## Amendments agreed to ECE/TRANS/WP.29/GRSP/2010/38 during the 48th session of GRSP

### Draft new Regulation on uniform provisions concerning the approval of enhanced Child Restraint Systems used onboard motor vehicles

Figure 1  
Arrangement for testing a forward-facing device

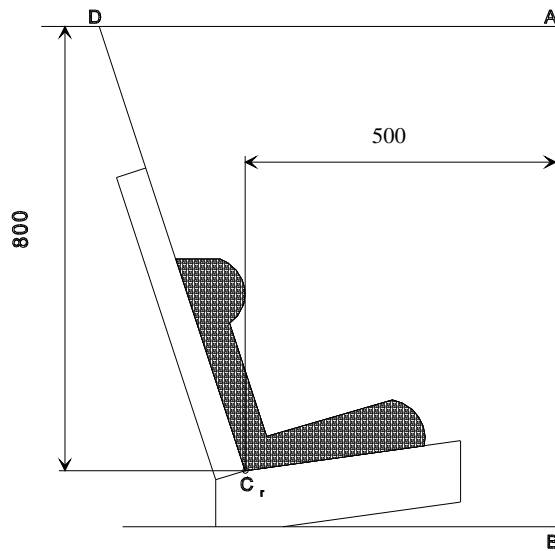
Head excursion: no part of the head of the dummy shall pass beyond the planes BA, ~~and~~ DA and DE as defined in figure 1 below. This shall be judged up to 300 ms or the moment that the dummy has come to a definitive standstill whatever occurs first.

Figure 2

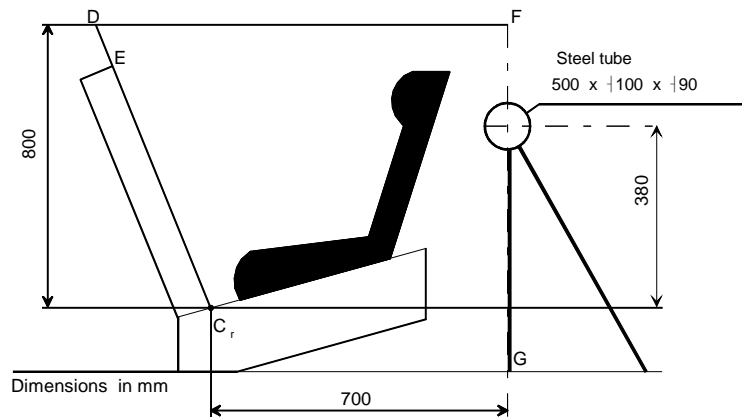
6.6.4.4.1.2.2. Head excursion: no part of the head of the dummy shall pass beyond the planes FD, FG and DE, as shown in figure 2 below. This shall be judged up to 300 ms or the moment that the dummy has come to a definitive standstill whatever occurs first.

Figure B.1

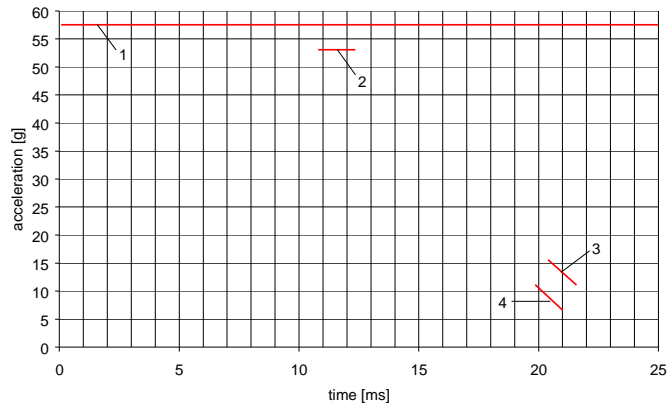
~~Deletion of Figure B.1~~

Figure 2 Main dimensions of [dummy](#)

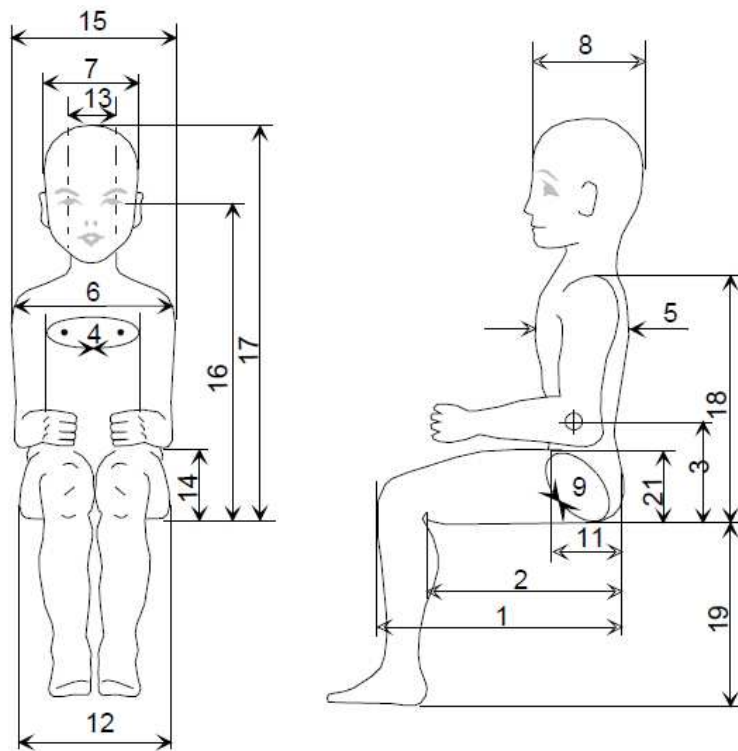
Request FTSS: Please add relevant dimensions to be included (e.g. is neck width (13) relevant?)
